SERVICE BULLETIN

Reference No. 32

SUBJECT: MAIN UNDERCARRIAGE POD - INCREASED RIGIDITY

FIGURE 1 SB N 22-53-1

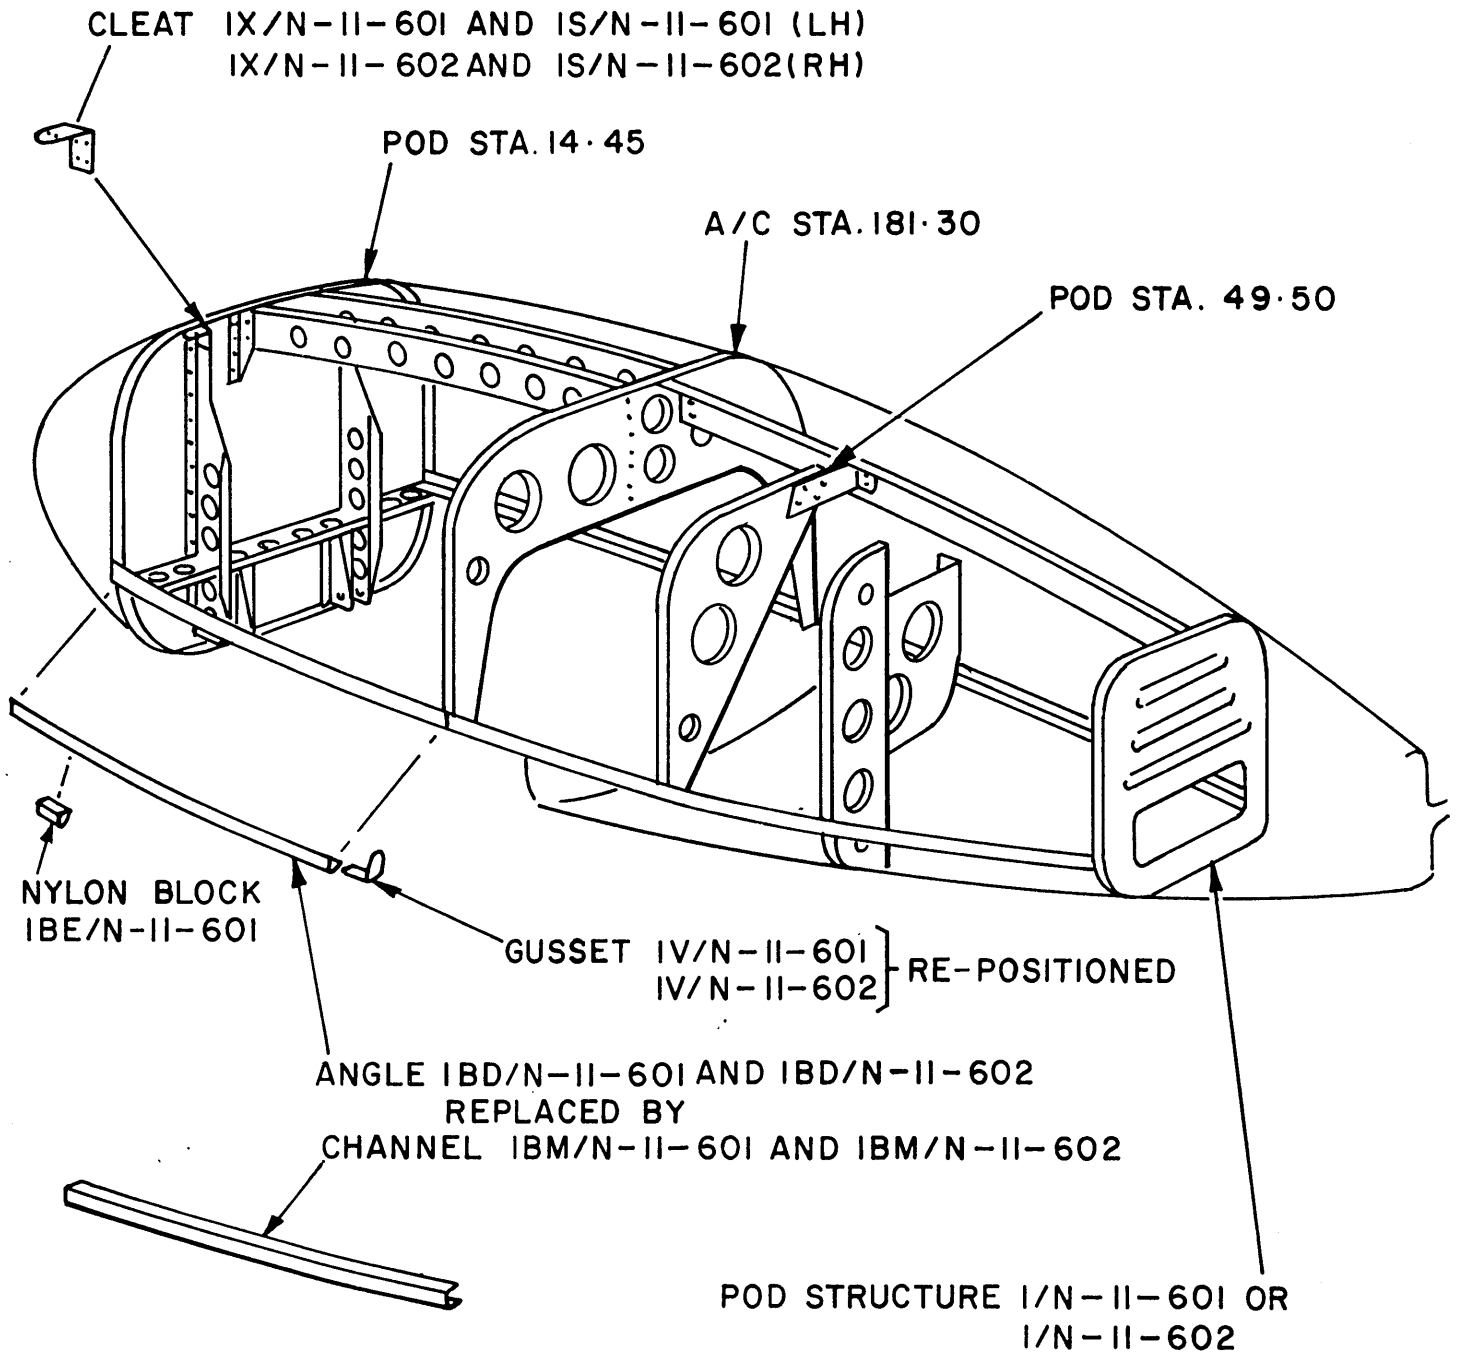
Part A. Stiffening of Door Opening (Ref. Fig. 1 and Fig. 2)

Part B. Stiffening of Bulkhead Pod STN. 14.45 (Ref. Fig 1 and 3)

Part C. Stiffening of Pod Frame STN 49.50 (Ref. Fig. 1 and 4)

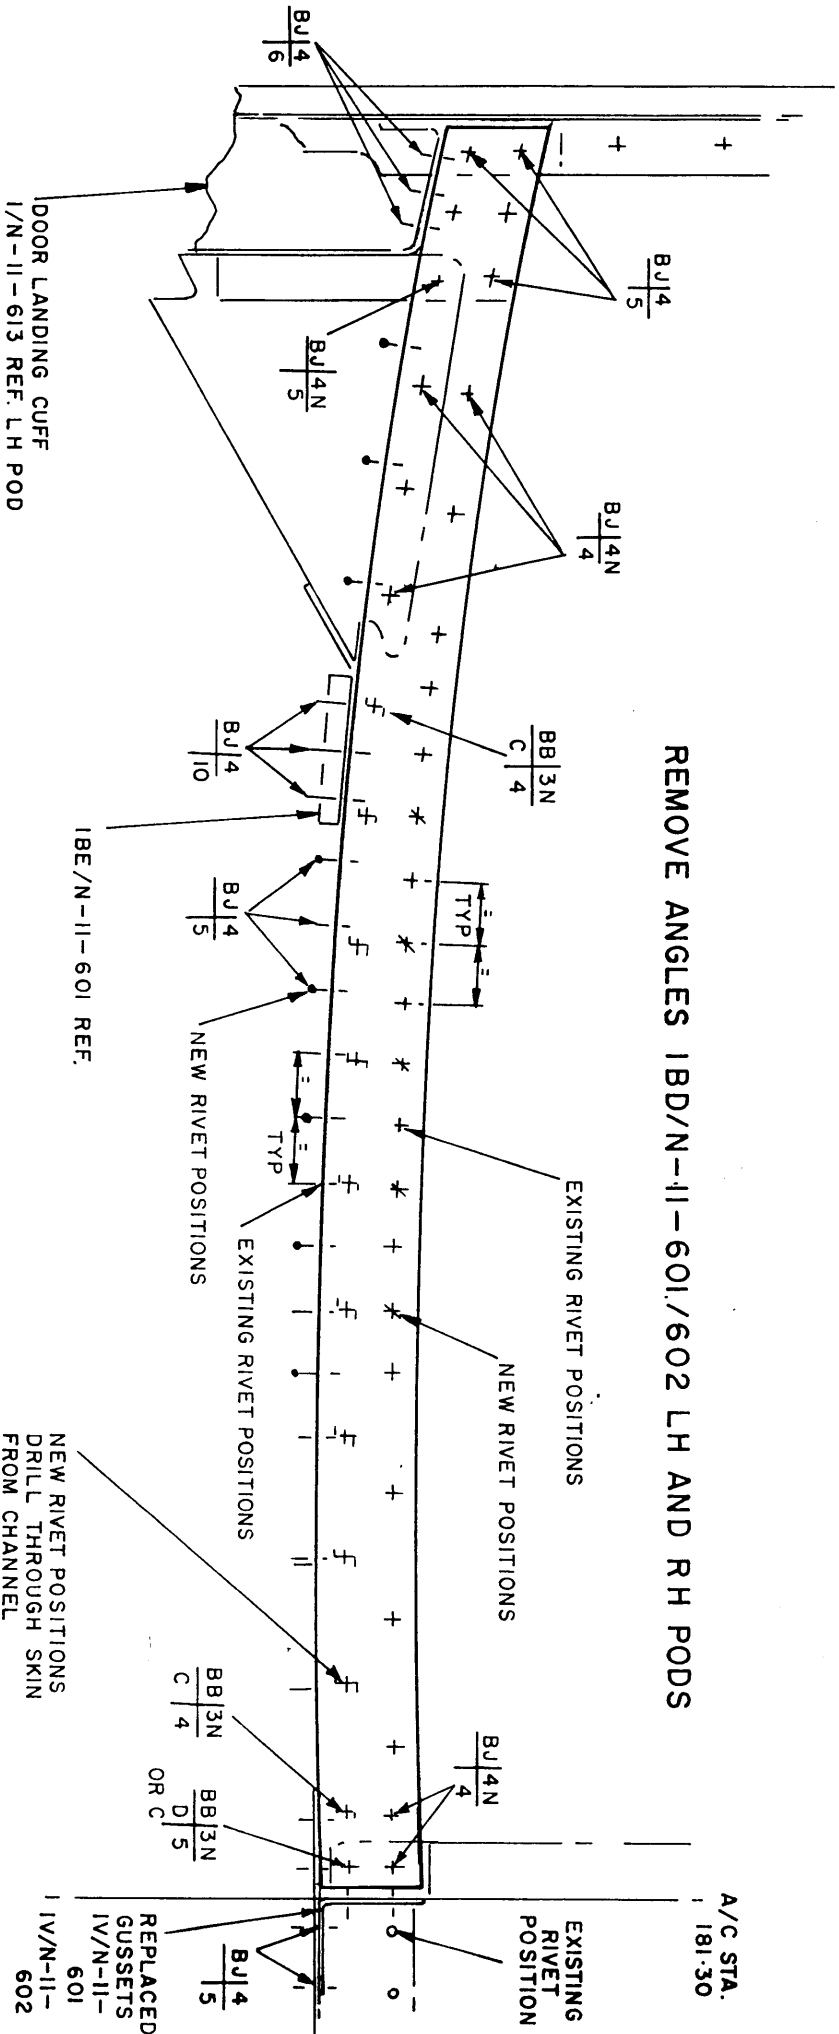
Remove 2 angles 1BD/N-11-601 and 602 located between pod STN 14-45 and Aircraft STN on pod 181.30 and discard.

On the pod at A/C STN. 181.30 remove 2 off gussets 1V/N-11-601 and 602. Refit these on the aft. face of frame 181.30 picking up existing rivet locations and new locations from gusset Ref. Fig. 2.

Fit the 2 channels 1BM/N-11-601 and 602 in the positions formerly occupied by the angles removed above, picking up existing rivet locations and interpitching mid way between, Ref. Fig. 2.

REMOVE ANGLES 1BD/N-11-601./602 LH AND RH PODS

FIGURE 3 SB N22-53-1

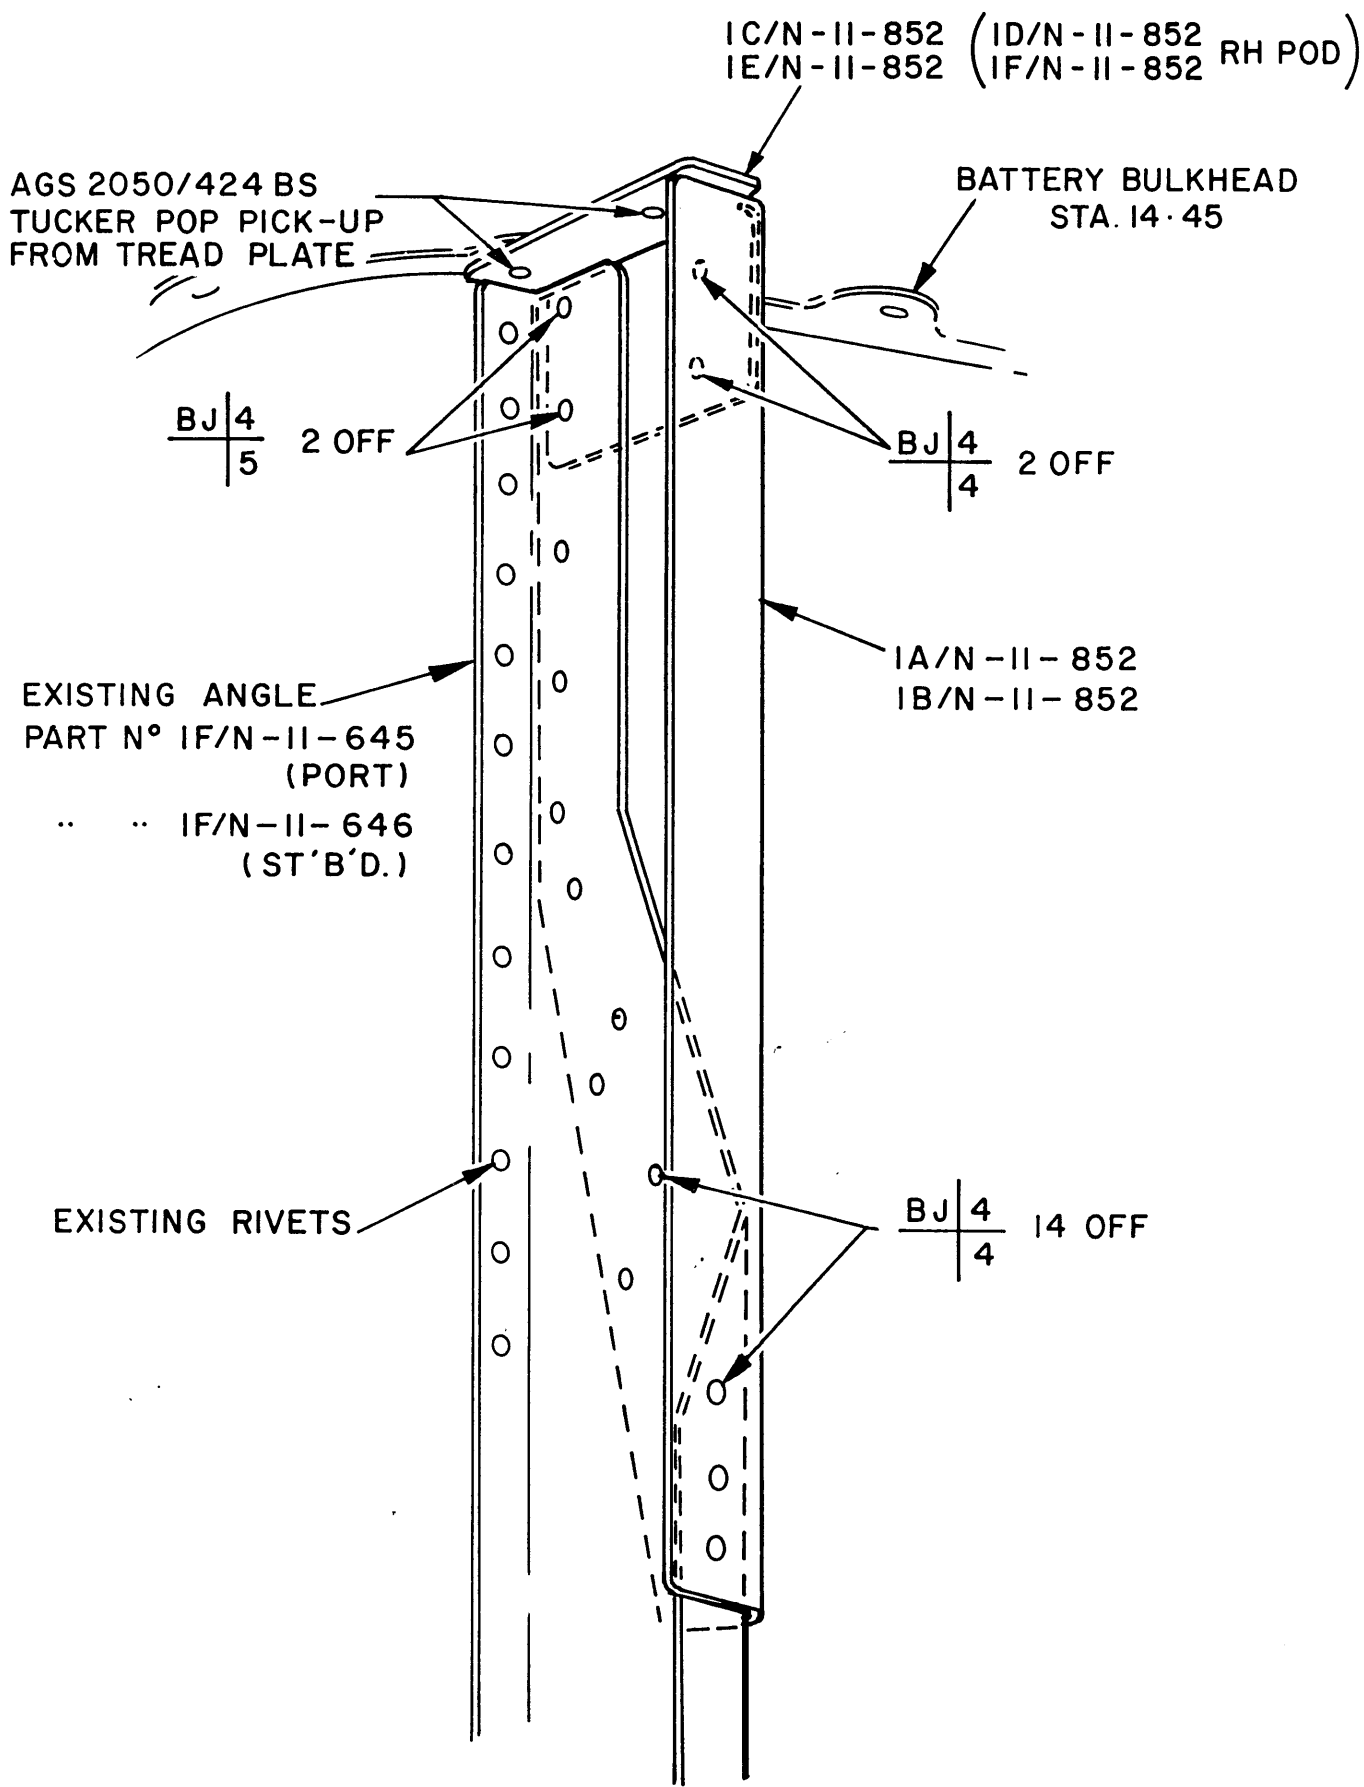
Remove 2 cleats 1X/N-11-601 and 1S/N-11-601 (1X/N-11-602 and 1S/N-11-602 R.H. Pod) at the top of vertical angles 1F/N-11-645 (1F/N-11-646 R.H. Pod).

Over the vertical angles locate and secure stiffening angles 1A/N-11-852 and 1B/N-11-852 with rivets MS 20470AD Ref. Fig. 3 and Fig. 2 for codes.

Assemble 2 new cleats 1C/N-11-852 and 1E/N-11-852 (1D/N-11-852 and 1F/N-11-852 R.H. Pod) Ref. Fig. 3.

VIEW LOOKING INBOARD L.H. POD L.H.S.
SIMILAR ON R.H.S. OF L.H. POD.
SKIN OMITTED

RIVETS MS 20470 AD, RIVET CODE SEE FIGURE 2

FIG.4 SB N22-53-1

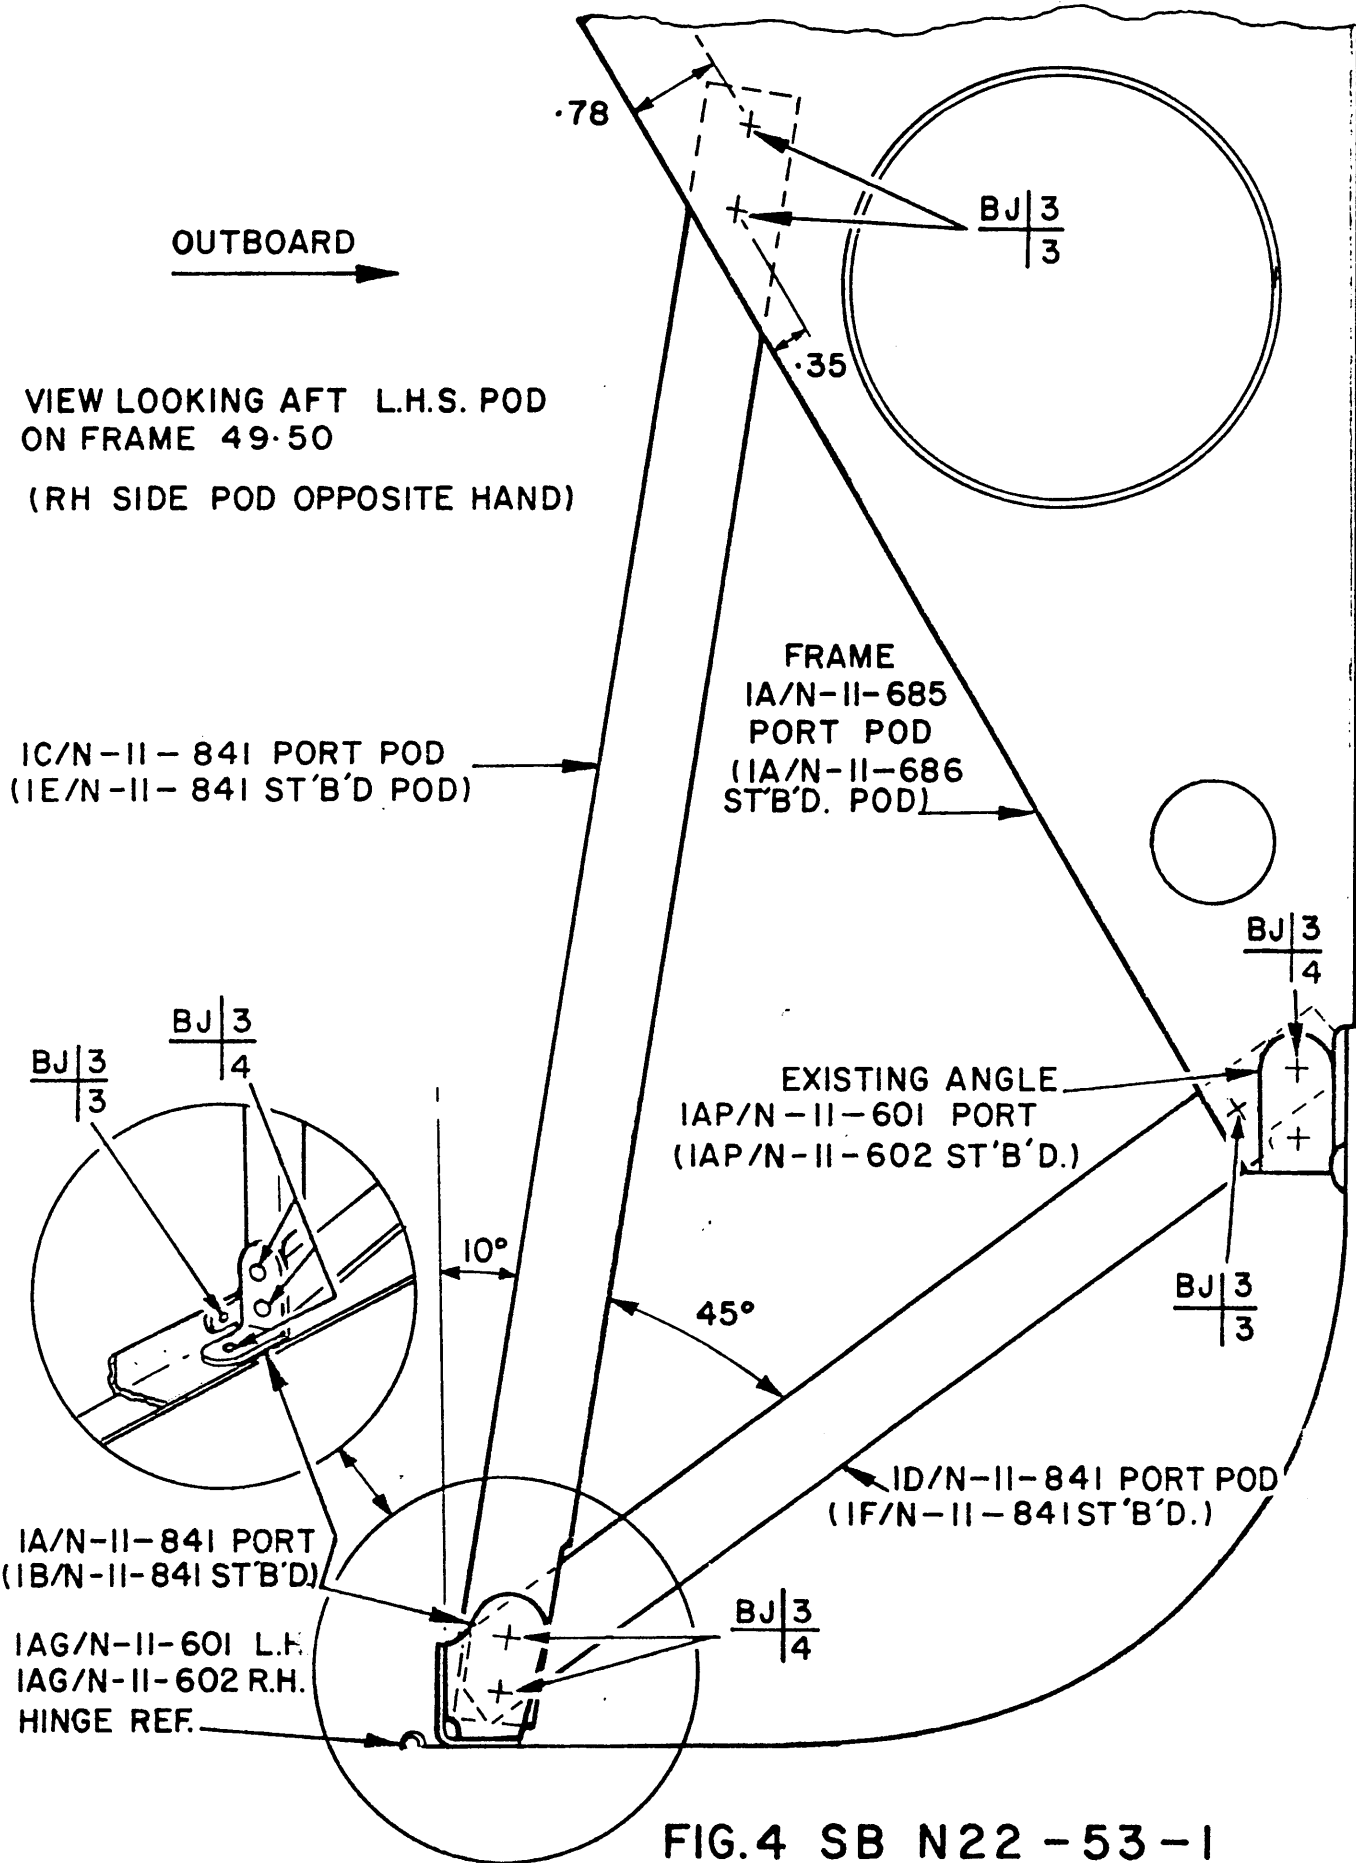
At the aft. door hinge, assemble bracket 1A/N-11-841 (1B/N-11-841 R.H. Pod) at pod STN 49.50 as shown on Fig. 4 (Ref. Fig. 2 for rivet specs.).

Remove upper rivet of existing angle 1AP/N-11-601 (1AP/N-11-602 R.H. Pod).

Install channel 1D/N-11-841 (1F/N-11-841 R.H. Pod) and channel 1C/N-11-841 (1E/N-11-841 R.H. Pod) to bracket 1A/N-11-841 with a 45° angle as indicated in Fig. 4.

As located, drill and secure upper end of channel 1C/N-11-841 (1E/N-11-841 R.H. Pod) to pod STN 49.50 frame 1A/N-11-685 (1A/N-11-686 R.H. Pod).
